**CDI ELECTRONICS  
OUTBOARD SERVICE BULLETIN**

CDI Bulletin # 2276 Rev.1

Models affected:     Johnson/Evinrude 60 HP 1986 (CE) through 1994 (ER)  
                            Johnson/Evinrude 65 HP 1987 (CU) through 1994 (ER)  
                            Johnson/Evinrude 70 HP 1989 (CD) through 1994 (ER)

Fig. 1

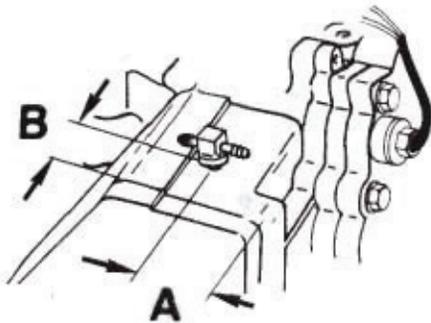
Relocate the water pump indicator outlet tee (for the pee tube) from the side of the engine block to the top of the engine cylinder block. This allows air to be vented from the top of the cooling system and helps ensure an adequate water level when idling.

1. Remove the indicator hose from the outlet tee and discard.
2. Remove the outlet tee.
3. Install a 1/8<sup>th</sup> inch NPT brass or aluminum pipe plug into the hole where the tee was located (use gel-seal on the threads). (See fig. 1)
